Caution Notice # 1 of 2005 Regulator Assembly

Regulator assembly Part # 505-069

Regulator Body, Part # 545-080

Kirby Morgan helmets and BandMasks

Fig.1

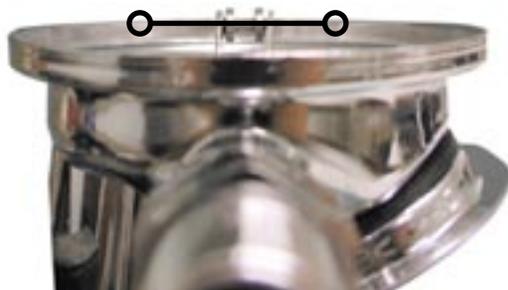
Correct position

In **Fig.1** note the parallel line drawn that represents the horizon. The roller lever's correct position is parallel to that.
